### APPEAL SUMMARY

<b>Appeal ID:</b> 21941	<b>Project Address:</b> 200 NW Royal Blvd, Lot #3
<b>Hearing Date:</b> 10/2/19	<b>Appellant Name:</b> Robert Oshatz
<b>Case No.:</b> B-004	<b>Appellant Phone:</b> 5036354243
<b>Appeal Type:</b> Building	<b>Plans Examiner/Inspector:</b> Jill Grenda, Nancy Thorington, Stacey Castleberry, Eric Engstrom
<b>Project Type:</b> residential	<b>Stories:</b> 3 <b>Occupancy:</b> R <b>Construction Type:</b> V-B
<b>Building/Business Name:</b> RHO LLC	<b>Fire Sprinklers:</b> No
<b>Appeal Involves:</b> Reconsideration of appeal	<b>LUR or Permit Application No.:</b> 06-107711-LU
<b>Plan Submitted Option:</b> pdf [File 1] [File 2] [File 3] [File 4] [File 5]	<b>Proposed use:</b> Single family residence

#### Appeal item 1

### **Openings in exterior walls at property line: Granted as proposed.**

CONSTRUCTION MANAGEMENT PLAN

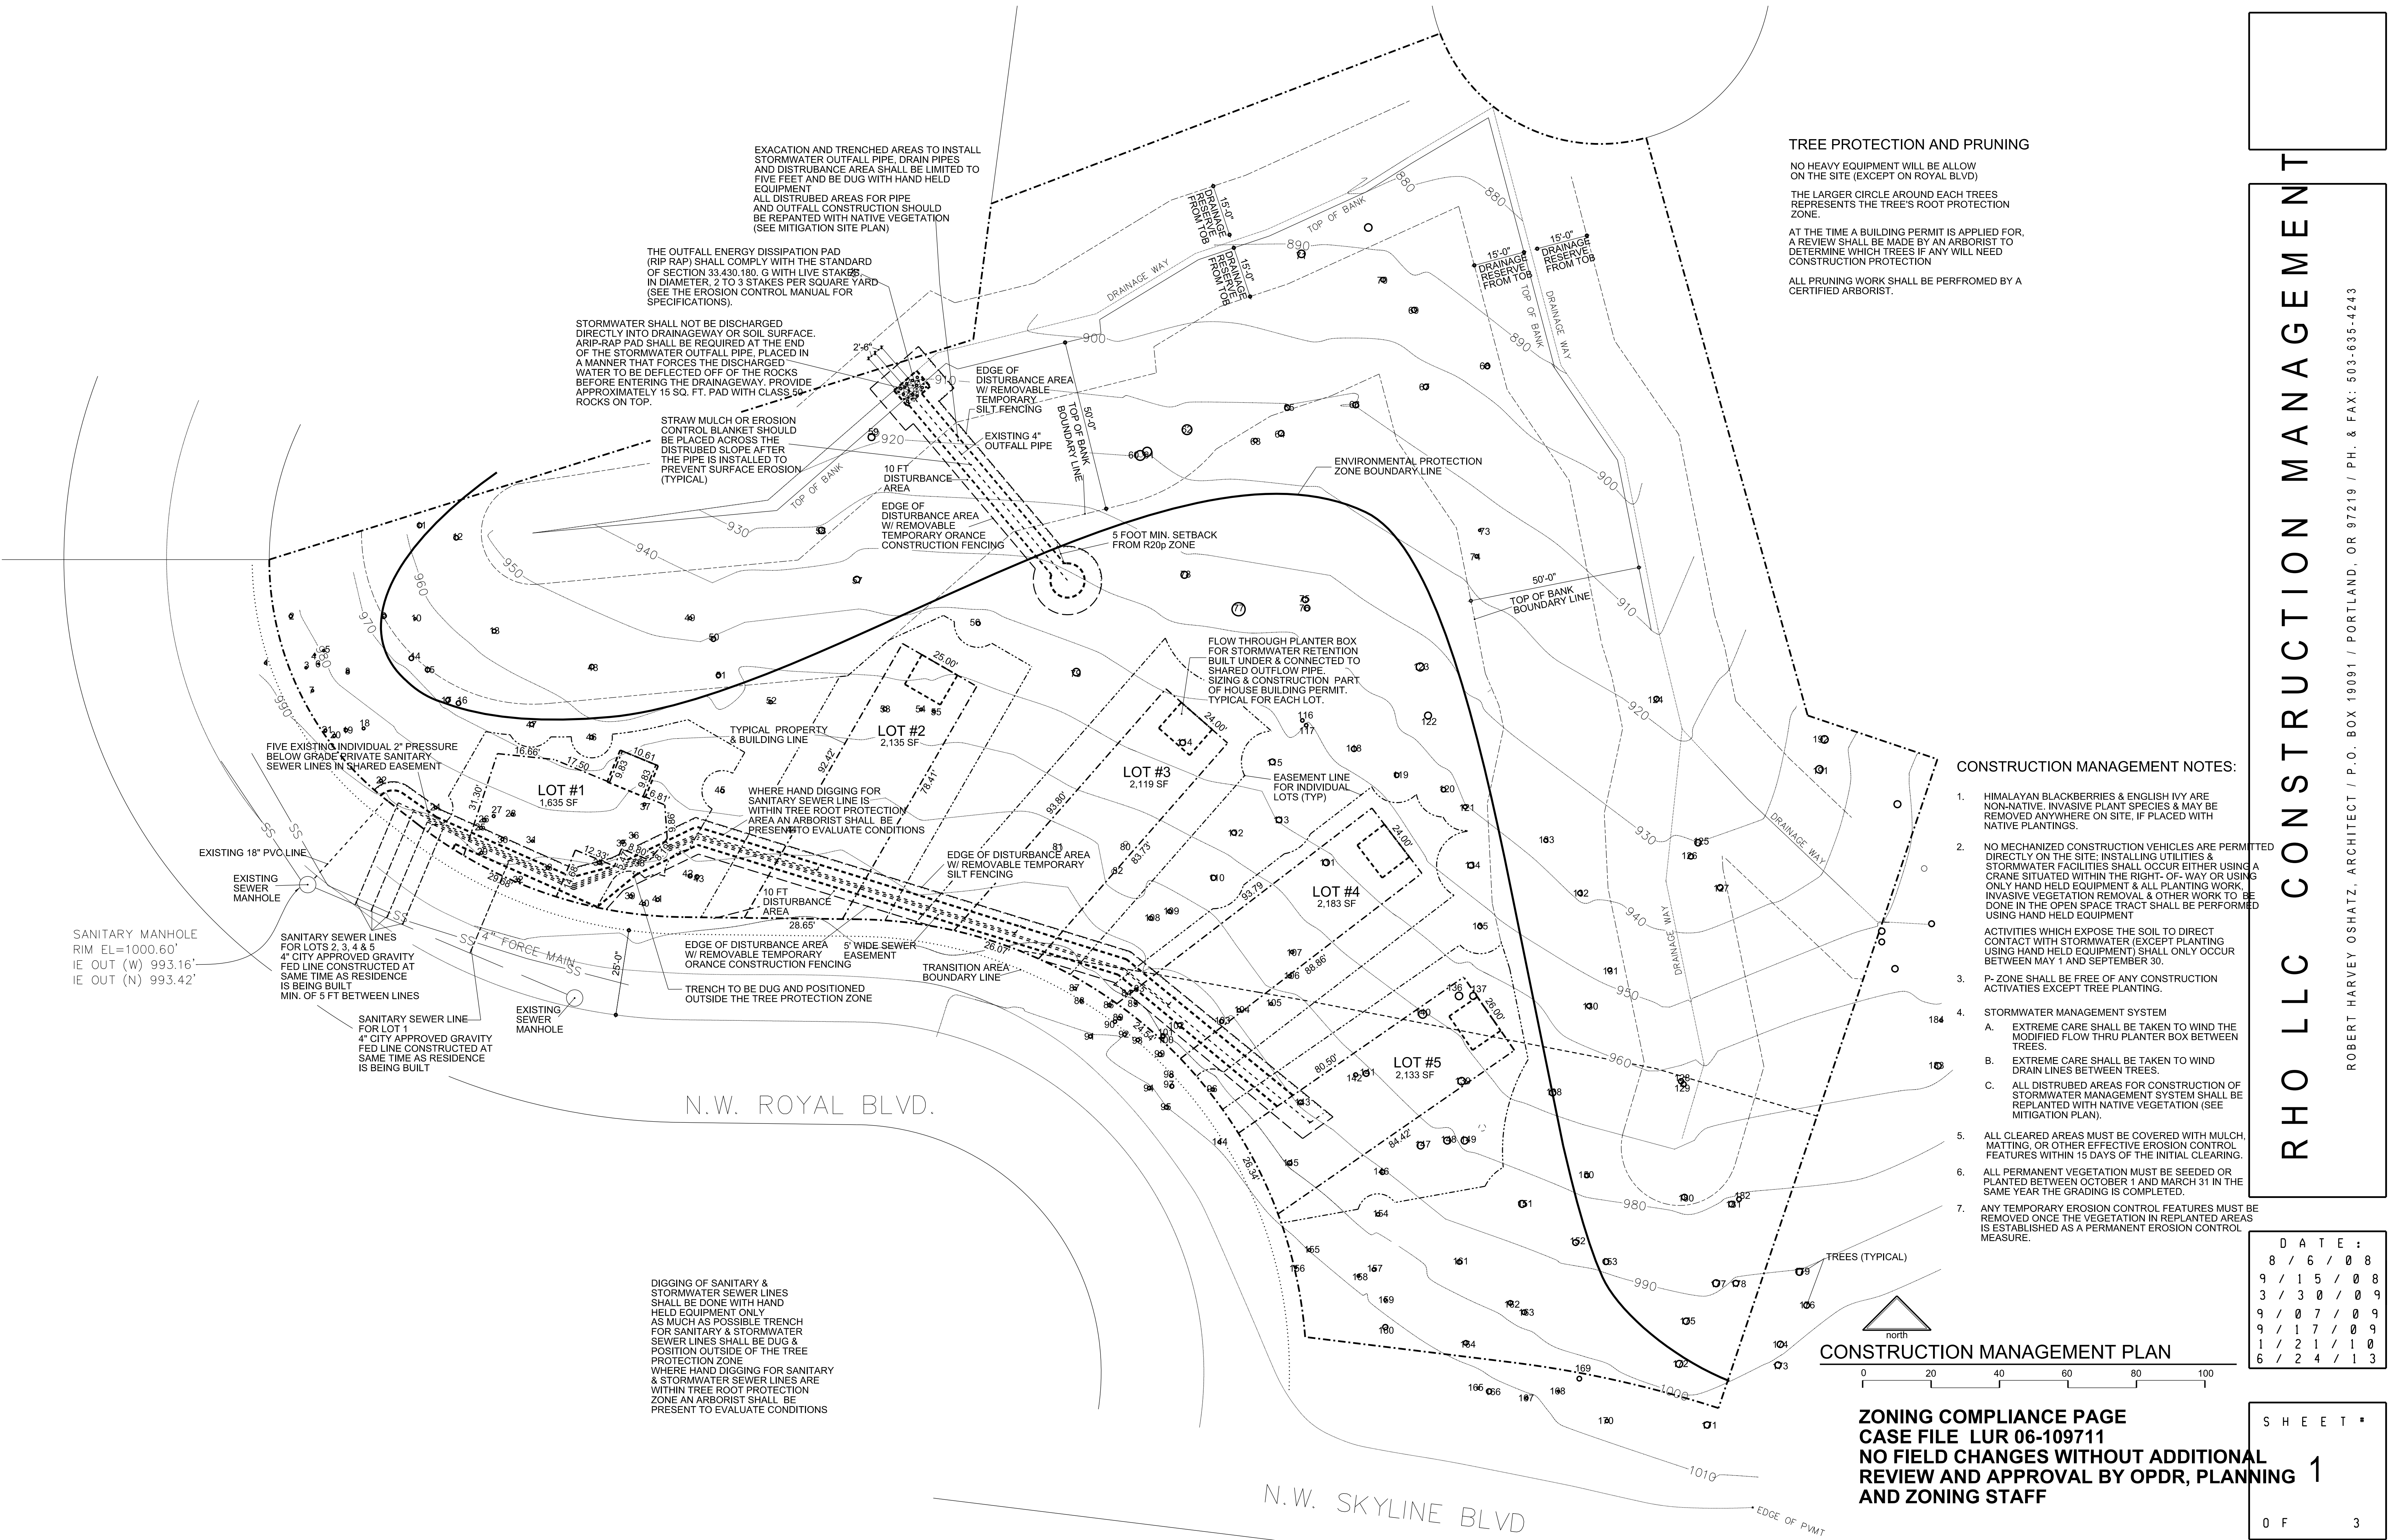
<b>Code Section</b>	R302
<b>Requires</b>	Openings are not allowed less than 3 feet from a property line.
<b>Proposed Design</b>	<p>Hearing Officer Ian Simpson approved the subdivision on Lot 7 Block5, Royal on March 28, 2007 (see LU 06-109711). In June of 2008, a similar appeal request was approved for Lot #1 of this subdivision (see Appeal ID: 5247).</p> <p>At this time, I am applying for a building code appeal on Lot #3 to cantilever as shown in the attach drawings into the subdivision private common green area. The steeply sloping downhill site requires steel H-piling supports. Horizontally at street level and supported by the piling will be a steel and wood bridge. The house will be built on top, hung from and cantilever out from the bridge. The cantilevering in a cantilever easement area beyond the individual property lines (see reason for alternate) will be of conventional wood frame construction supported by steel and engineered lumber beams. The finish exterior walls and roof will be of sheet-metal, wood and stucco siding.</p> <p>As part of the approval process for the subdivision the finished houses will be at least 20 feet from any structure associated with Lot #2 and Lot #4.</p>

Section R302.1 of the 2005 Oregon Residential Specialty Code is concerned with public safety. It requires that openings are not permitted less than 3 feet from a property line. Essentially this results in a separation of openings between structures of at least 6 feet to prevent fire spreading. In this appeal, for Lot #3 will be at least 20 feet away from any future structure on Lot #2 and Lot #4 (as required by the subdivision approval). This is greatly exceeding the 6 feet suggested by R302.1. Thus, the design follows the intent of the code and more than satisfies it.

The cantilever deck which will be constructed of steel beams, 4x14 joist and 2x6 outdoor decking; the roof will be Class B materials, the walls are cad in sheet-metal, wood and stucco and soffits will be 5/8" fire rated gypsum board; making the structure at least as safe as any other residence in the neighbor. In addition, I am willing to work with the Fire Marshall's office to mitigate any of their concerns.

The Administrative Appeal Board finds that the information submitted by the appellant demonstrates that the approved modifications or alternate methods are consistent with the intent of the code; do not lessen health, safety, accessibility, life, fire safety or structural requirements; and that special conditions unique to this project make strict application of those code sections impractical.
